ADDENDUM #1

CITY HALL HVAC UPGRADE

BID #15/16-002 – PWP# WA-2015-224

JOB NAME: SPARKS CITY HALL HVAC UPGRADE

ADDENDUM #1 SKETCH #1 DRAWING NO.: MI.7

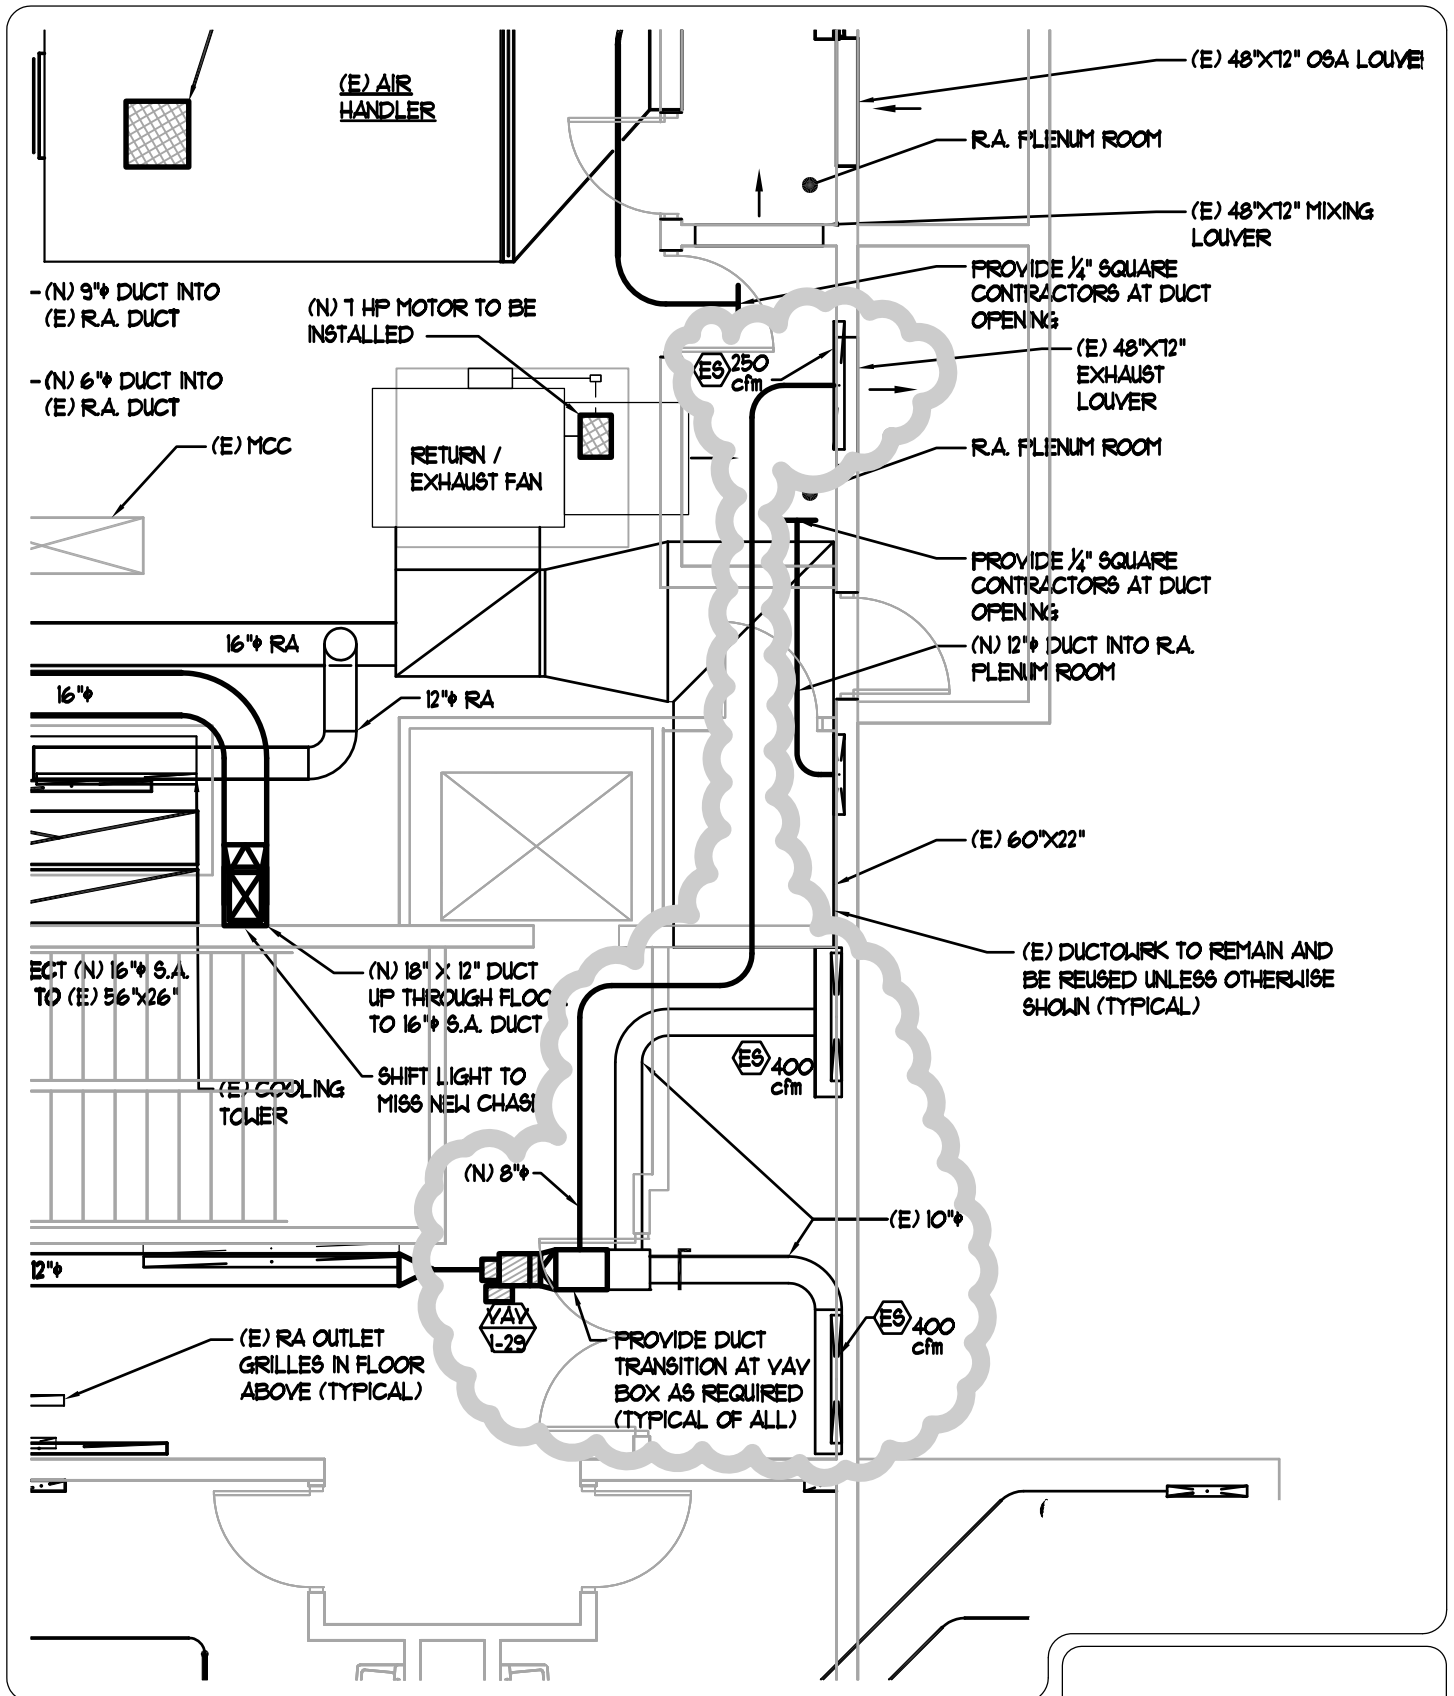
3. VAV Box 1-29 shall be changed to a unit size 10 and shall have the same air flow rates and settings as VAV Box 1-33. See the attached Sketch-1 for duct revisions associated with VAV 1-29.

VAV-29 DUCT LAYOUT REVISIONS

ADDENDUM-1 SKETCH-2 DRAWING NO.: DETAIL 1/M6.1

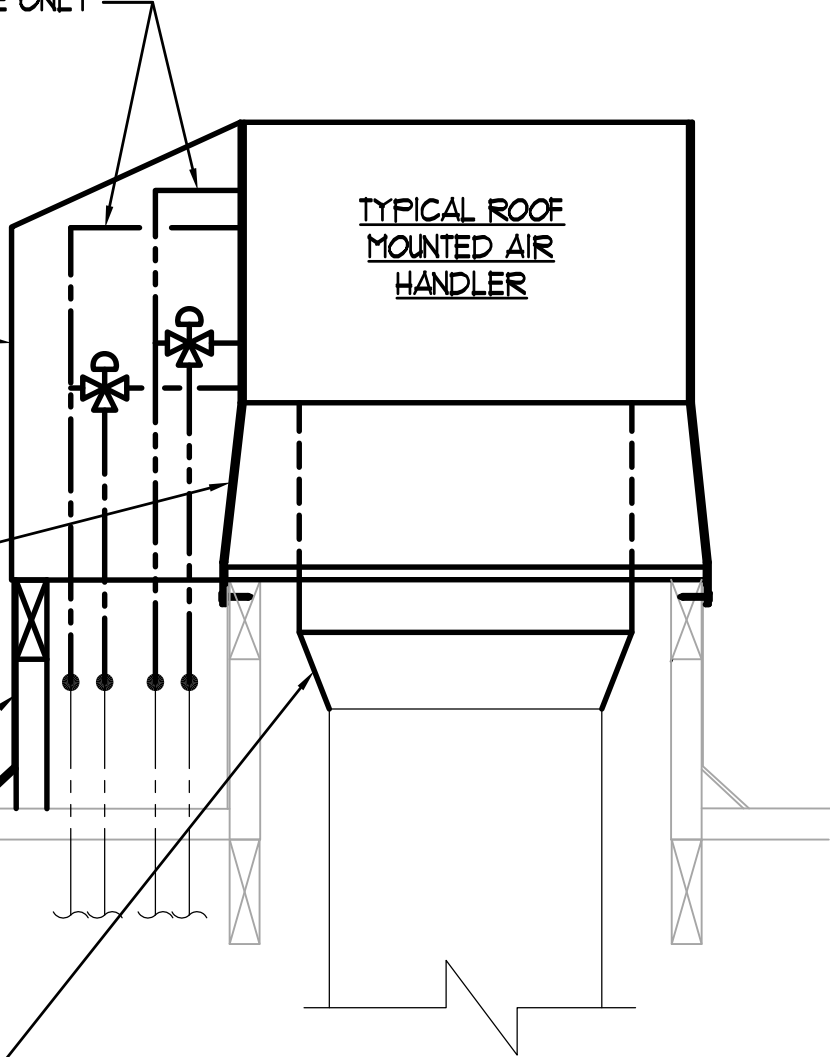
4. For clarity, the doghouse enclosures at the air handler that are required for enclosing the hot water and chilled water piping arrangement, control valves and associated components are to be custom built on site. The exact size and location relative to the air handler shall be verified in the field and then submitted as a shop drawing for approval. The enclosure shall have a galvanized sheet metal finish (both inside and exterior) with a 2” rigid insulation between sheet metal panels. It shall be constructed to the same standard as specification 233119 section 2.2.B. See the attached Sketch-2 for the revised detail 1/M6.1. The roof curb shall be extended for the doghouse enclosure as required and flashed into the roof per the existing roof manufacturer’s requirement.

EXTEND PIPING AND TRANSITION AS REQUIRED TO CONNECT THE TO THE NEW AIR HANDLER COILS. PIPING IN THIS DETAIL IS DIAGRAMATIC IN NATURE AND IS SHOWN FOR REFERENCE ONLY

FIELD FABRICATED DOGHOUSE ENCLOSURE WITH ACCESS DOOR TO HOUSE THE PIPING ARRANGEMENT FOR THE COILS CONNECTIONS AND CONTROL VALVE COMPONENTS

MICRO-METAL OR EQUAL, FACTORY BUILT CURB ADAPTOR MINIMUM 12" HEIGHT TO BE INSTALLED PER MANUFACTURERS REQUIREMENTS

EXTEND CURD AND FLASH INTO (E) ROOF AS REQUIRED BY MATERIAL ROOFING MANUFACTURER

EXTEND DUCTS AND TRANSITION AS REQUIRED TO CONNECT THE EXISTING DUCTWORK TO THE NEW AIR HANDLER UNITS (TYPICAL OF ALL SA AND RA DUCTS)

ADDENDUM-1 SKETCH-3 DRAWING NO.: M2.5

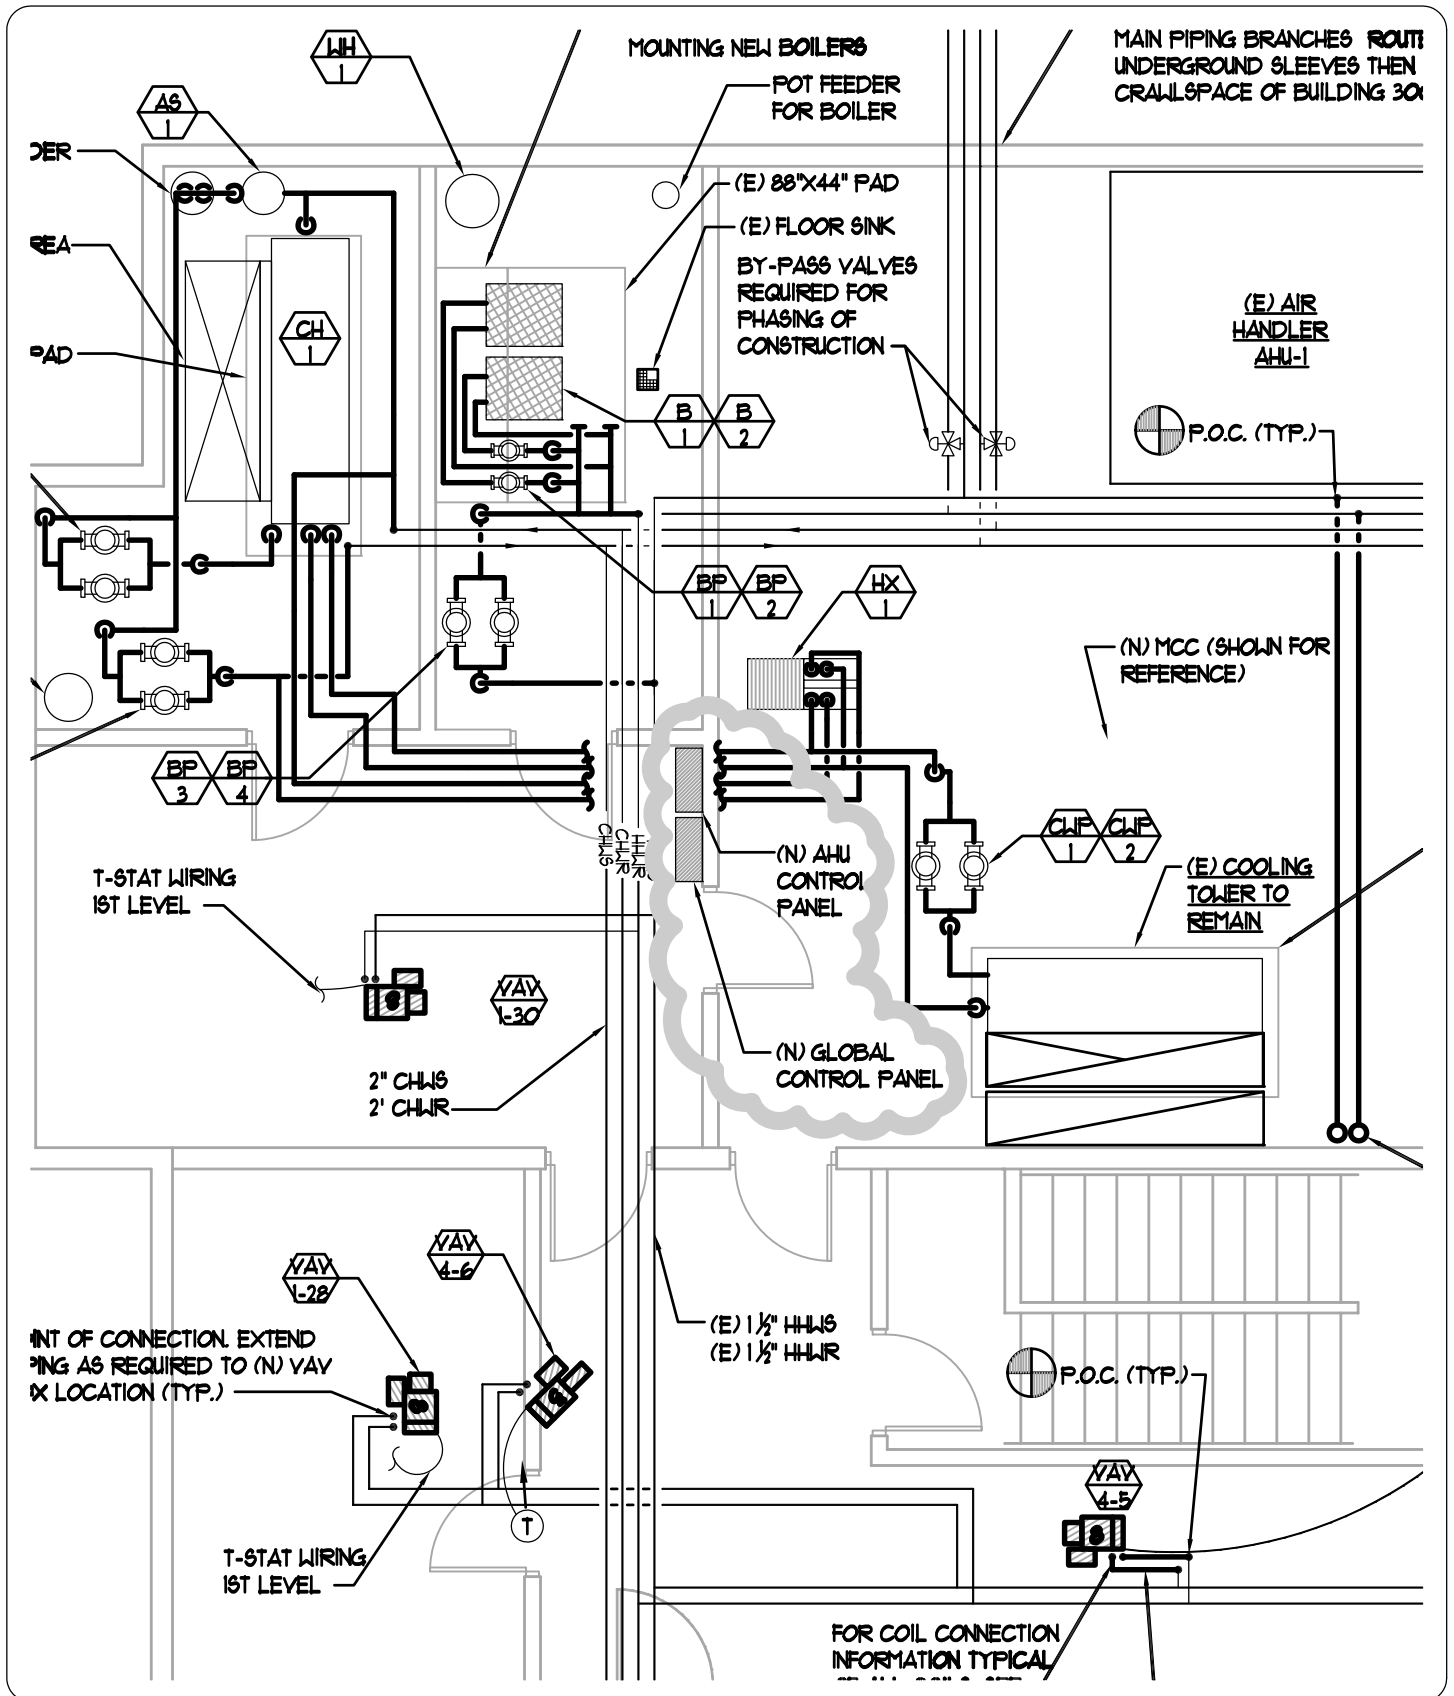
10. The main global control panel and the AHU-1 control panel shown in the main air handler room on sheet M2.5 will need to be moved and installed directly on the other side of the wall in the adjacent Mech/Elec. room directly to the east. See attached Sketch-3

CONTROL PANEL RELOCATION
